**PLANNED UNIT DEVELOPMENT
& SUBDIVISION STAFF REPORT****Date: March 7, 2013****DEVELOPMENT NAME**

Westwood Plaza Subdivision

CONTEMPLATED USEPlanned Unit Development Approval to allow multiple
buildings on a single building site, with shared access between multiple building sites, and
Subdivision approval to create 5 lots.**TIME SCHEDULE
FOR DEVELOPMENT**

SITE PLAN

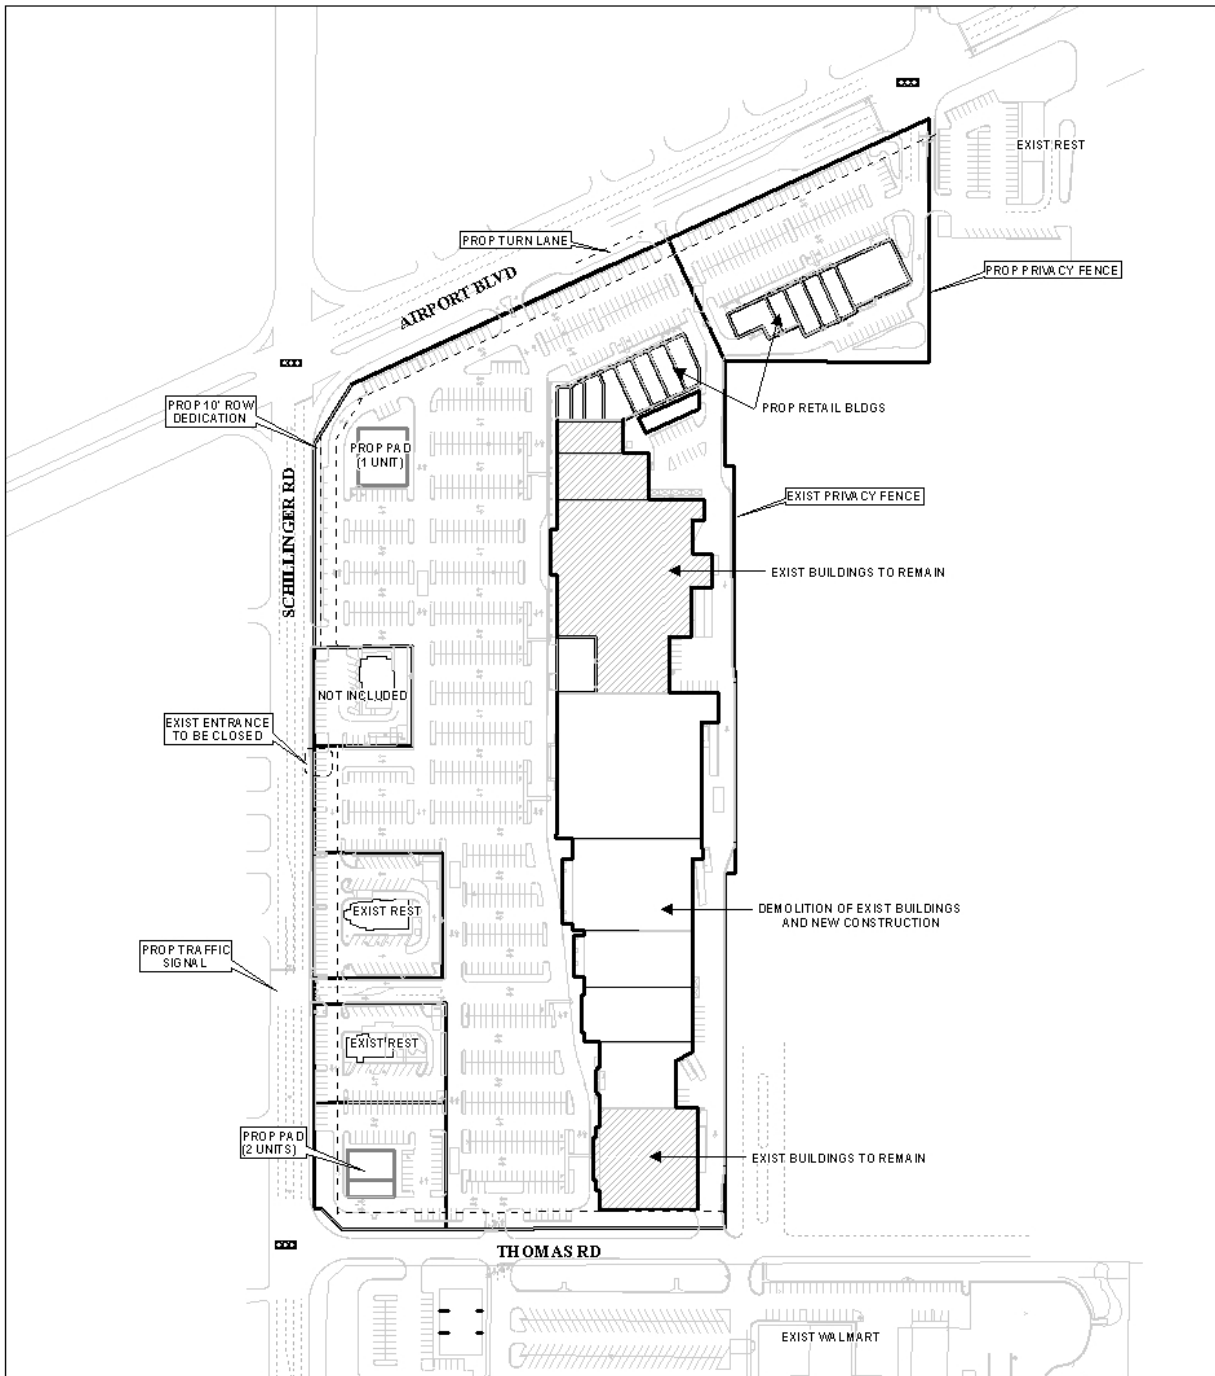
The site plan was revised to depict the relocation of the proposed traffic signal to Thomas Road. The revised site plan depicts two entrances onto Schillinger Road, three to Airport Boulevard, and two to Thomas Road. Traffic Engineering comments indicate that additional changes will be required prior to their ultimate approval of the proposed development.

The revised site plan has a note which states that the site will have 1,149 parking spaces, a reduction over the originally submitted site plan, which noted 1,164 parking spaces. A specific proposed tenant mix was not provided, however, sufficient parking spaces will be provided to allow a mix of restaurant and retail / office uses.

No buffer is depicted on the revised site plan or the tree/landscape plan where the site abuts the residential district to the East of the site, as required by Section 64-4.D. of the Zoning Ordinance.

The revised site plan depicts existing and proposed buffer fencing where the site abuts residential development to the East.

- 1) The site plan to does not reflect right-of-way dedication along Schillinger Road, as specified by the Major Street Plan component of the Comprehensive Plan as well as the Subdivision Regulations;
- 2) The site plan does not fully comply with the tree and landscape requirements of Section 64-4.E. of the Zoning Ordinance; and
- 3) A residential protection buffer is not depicted along the East property line, as required by Section 64-4.D. of the Zoning Ordinance.

SITE PLAN

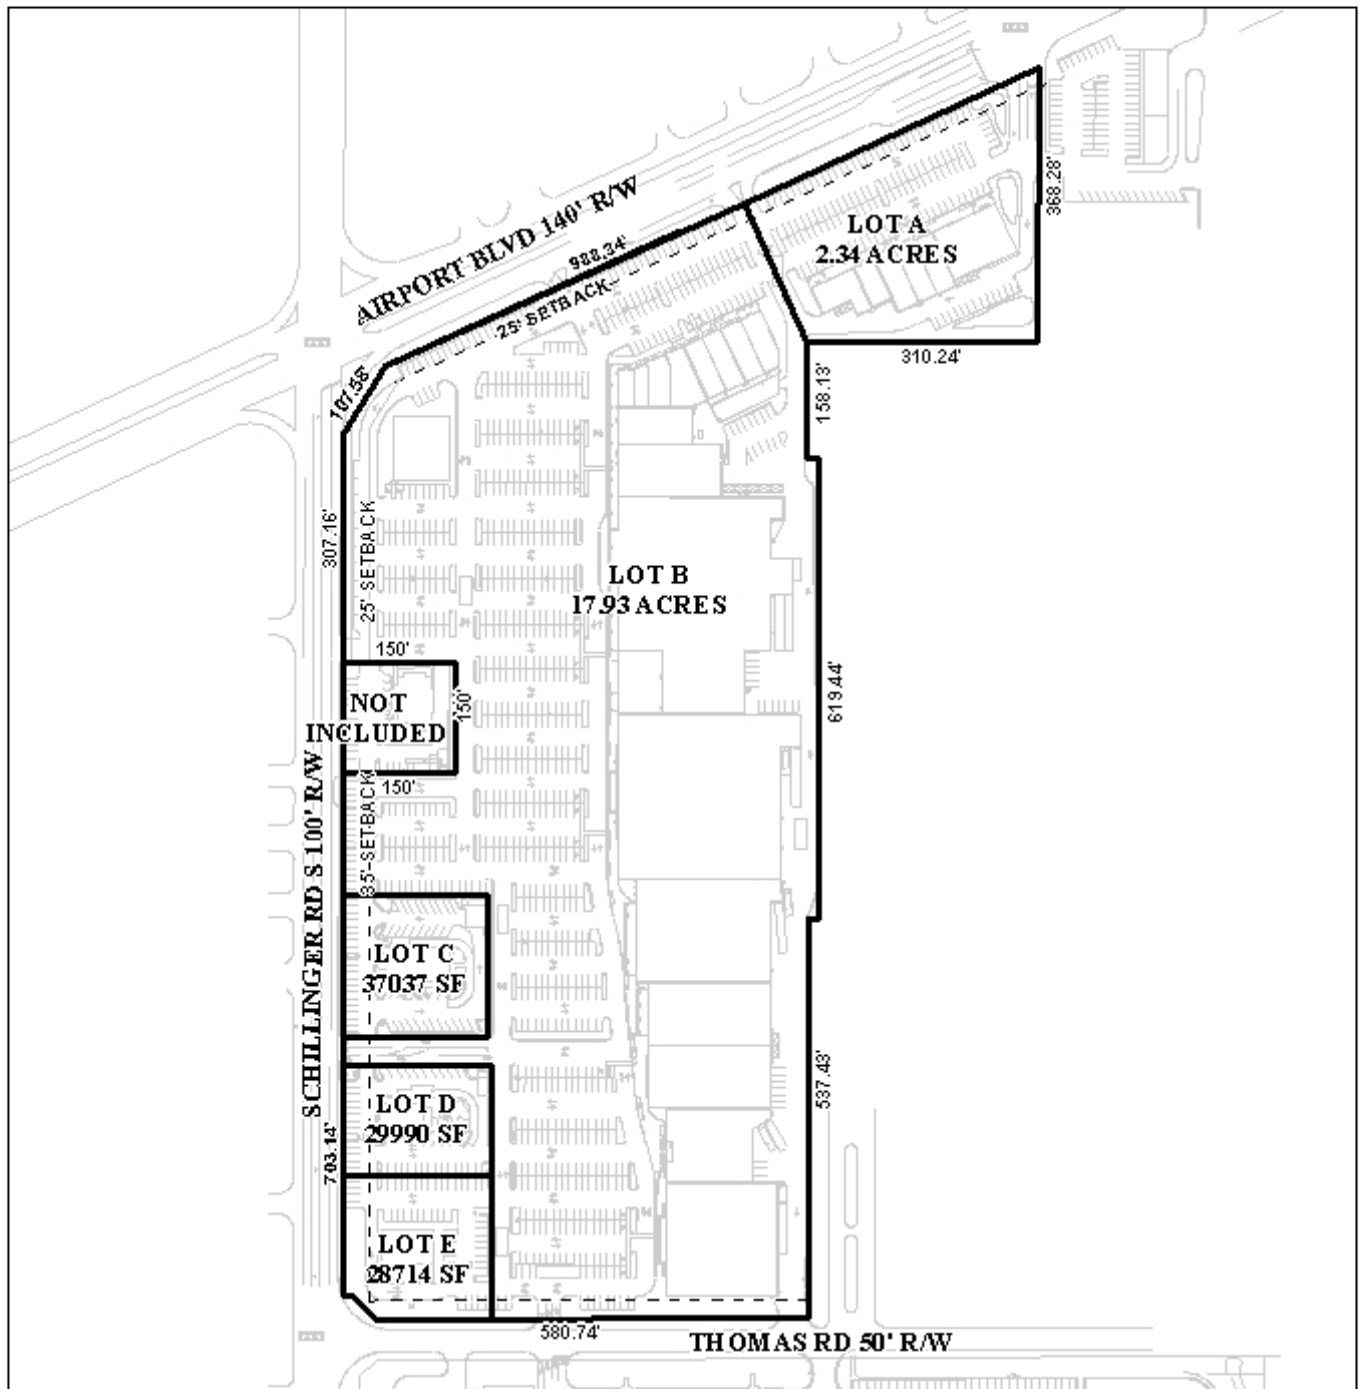
The revised tree / landscape plan does not reflect the proposed right-of-way dedication depicted on the site plan and Subdivision plat. Furthermore, there is a discrepancy in the number of trees that are proposed: the tree/landscape plan quantities chart lists a total of 216 trees, staff counted 214 trees, and the applicant's expanded and revised narrative letter states a total of 186 trees (see table below). It should be pointed out, however, that the applicant proposes to provide 32 frontage trees that will be larger 6-inch caliper specimens, exceeding the 3-inch caliper minimum required.

As previously noted, the site will not comply with the tree and landscape requirements of Section 64-4.E. of the Zoning Ordinance, even with the revisions submitted for the August 8th meeting. The site will only achieve 72% of the required landscape area (being 31,355 square feet short of the total required), and will be 13 trees short overall regarding tree compliance. The table at right illustrates the proposed and required items regarding tree and landscape compliance.

As the table additionally illustrates, the applicant will not provide the required number of frontage trees per street frontage, though as previously mentioned, they will be planting larger trees.

- 1) The site plan does not fully comply with the tree and landscape requirements of Section 64-4.E. of the Zoning Ordinance.*
